CITY OF FISHERS AGENDA

BOARD/COMMISSION: Planned Unit Development (PUD) Committee Meeting

DATE: 3/1/2023, at 5:00 PM

Planned Unit Development (PUD) Committee Staff Report

PARKVIEW TOWNS AT SAXONY

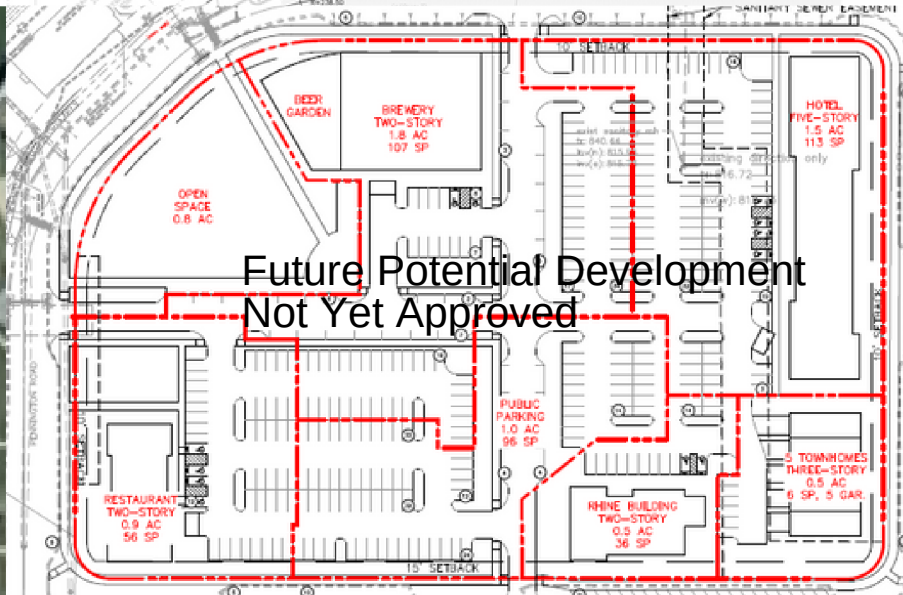
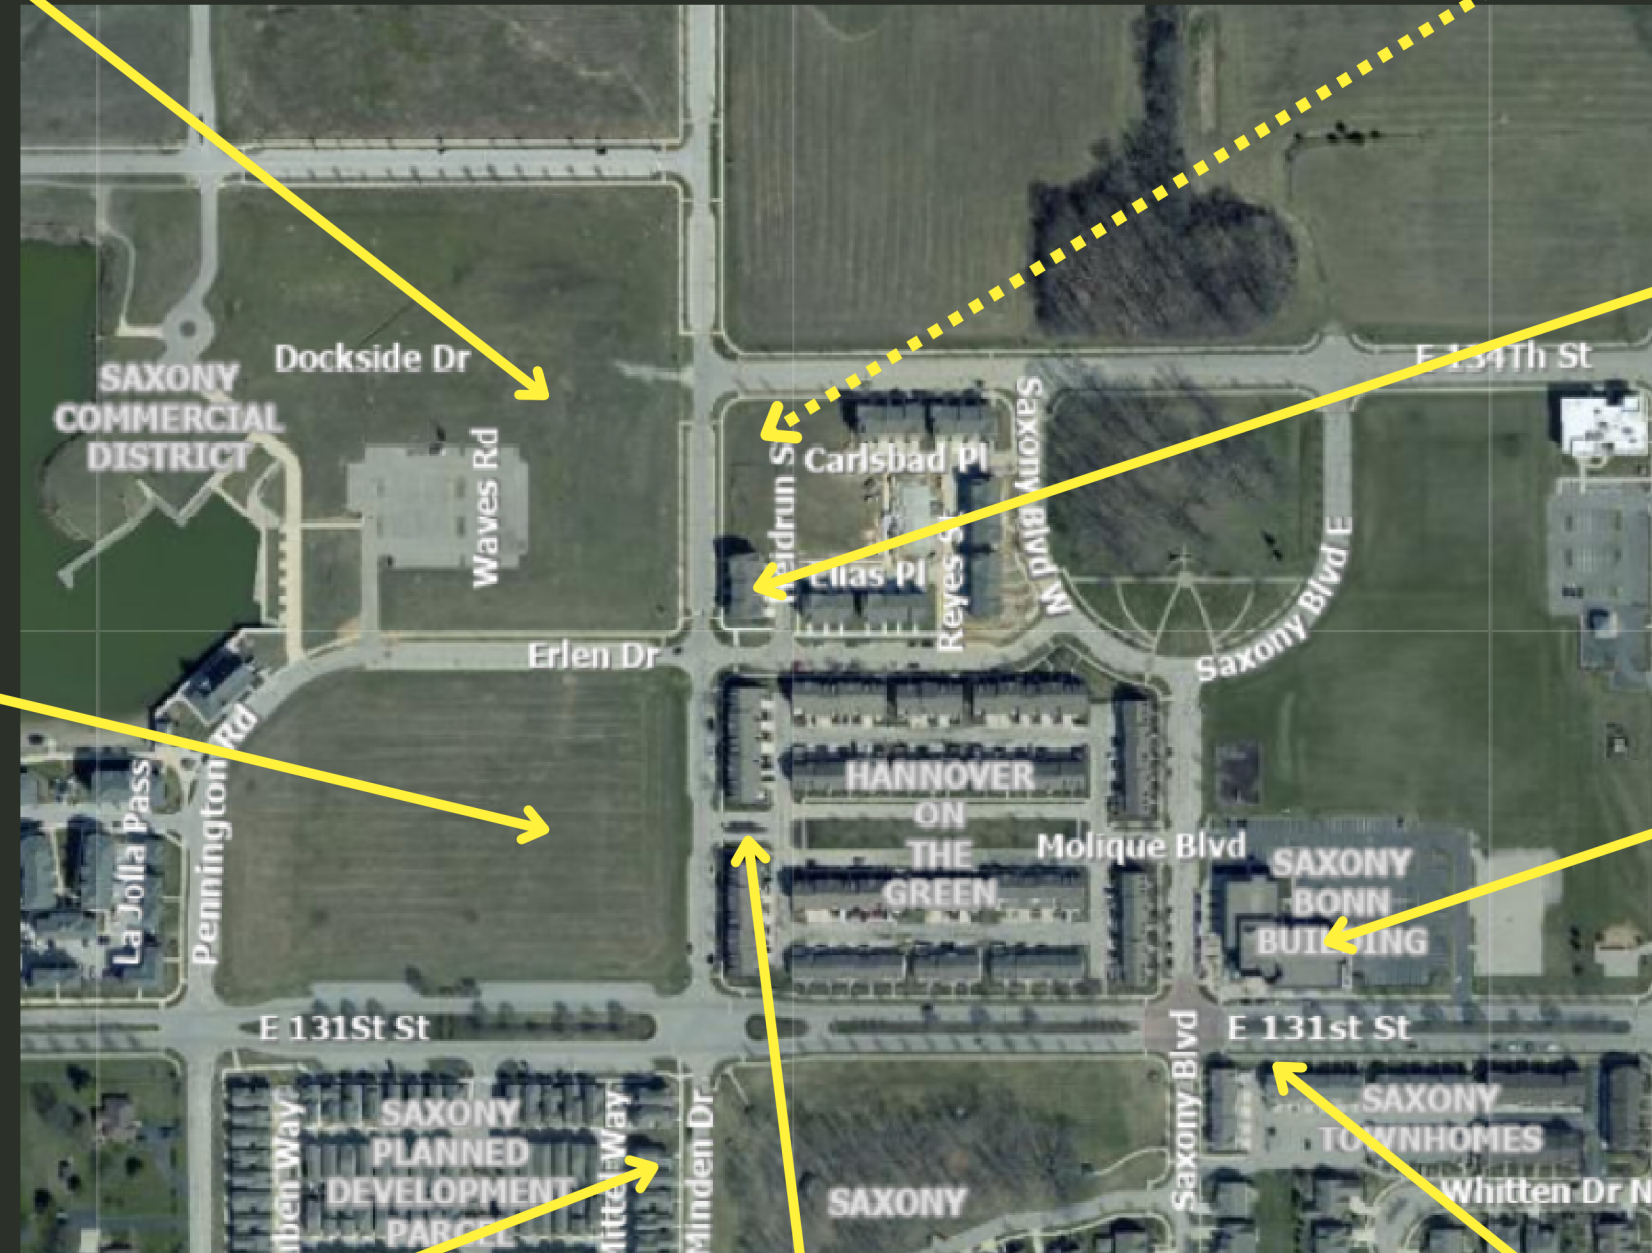
Staff has had concerns about the change to the architectural styles. The existing Parkside Towns are a modern style whereas the proposed elevations for Parkview Towns is a more colonial look. Parkview Towns will only include 4 buildings, so staff is concerned the abrupt shift in character would look strange in such a small area of the already built out block of townhomes. Because of these concerns, staff had the proposed elevations reviewed by Veridus Architecture. Their recommendations were provided to the petitioner and have been included on this report. The petitioner has not addressed the comments.

c. Incorporate architectural features on all sides of a building façade facing a Public View.	Required	Provided
d. Provide for wayfinding signage and create a unique identity for each building or community, by incorporating complimentary variation in design.	Required	Information not provided

a. Incorporate at least two (2) types of modulation in the façade plane facing a Public View, including, but not limited to: projections, recesses, and step backs that articulate wall planes and break up building mass.	Required	Only 1 type of modulation is provided per townhome

b. Façades equal to or longer than 20' facing a Public View shall provide a minimum total modulation area of 20% of the horizontal wall span, with a minimum vertical height of at least 3' tall. Porches and balconies, at least 6' in depth may count toward this requirement.	Required	Not provided

c. Modulation for qualifying projections, pop outs, bays, recesses, and varied setbacks, must be a minimum depth of 12" from the primary façade plane. A minimum 50% of total modulation must be visible over permanent barriers, such as berms and fencing, from described areas.	Required	Not provided

f. Second-story residential façades may not extend to the front face without additional façade modulation or additional material types and architectural accents.	Required	Not provided
